COA 17-57

806 Citrus Avenue

Installation of a 4 feet tall white rail fence.

HISTORIC PRESERVATION BOARD : PUBLIC HEARING

Site Plan of the Property

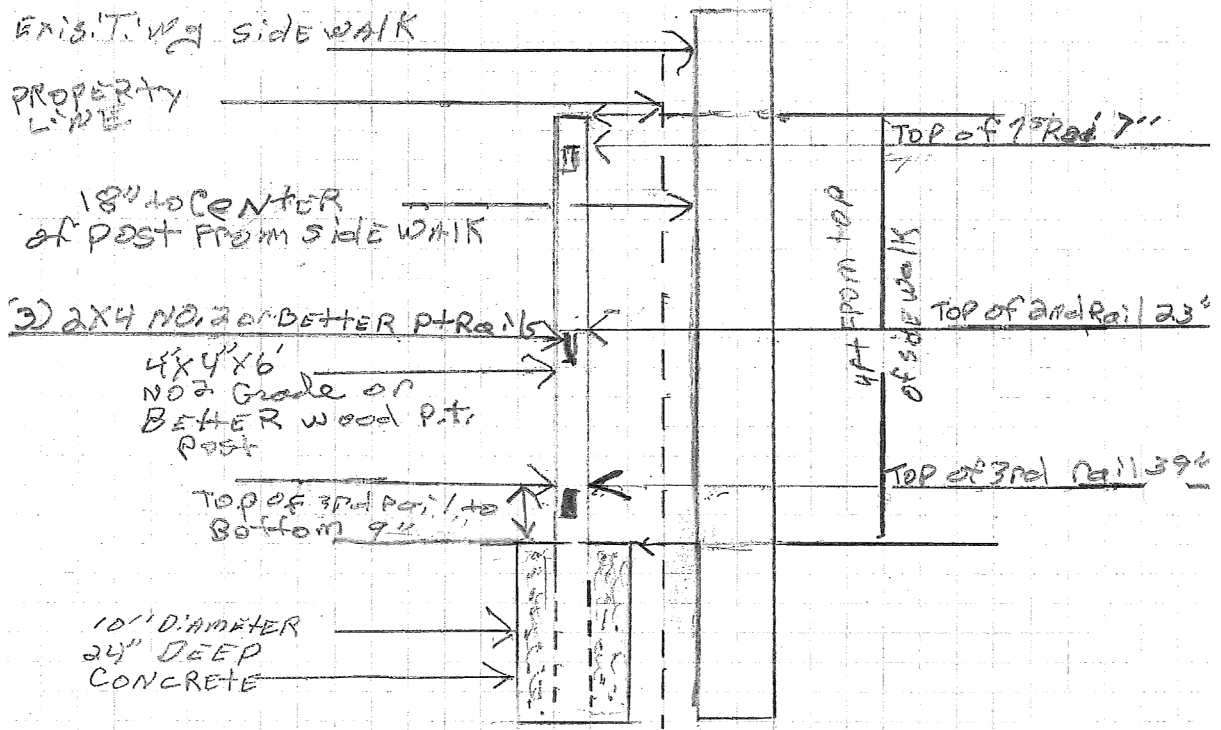
The current proposal seeks to install a 4 foot high, split rail wooden fence that is incompatible with architectural features of the surrounding properties and their environment.

Staff recommends that the Board deny the request as submitted based upon Secretary of Interior Standard 9.

If approved the proposed fence shall meet Sec. 22-53 requirements.
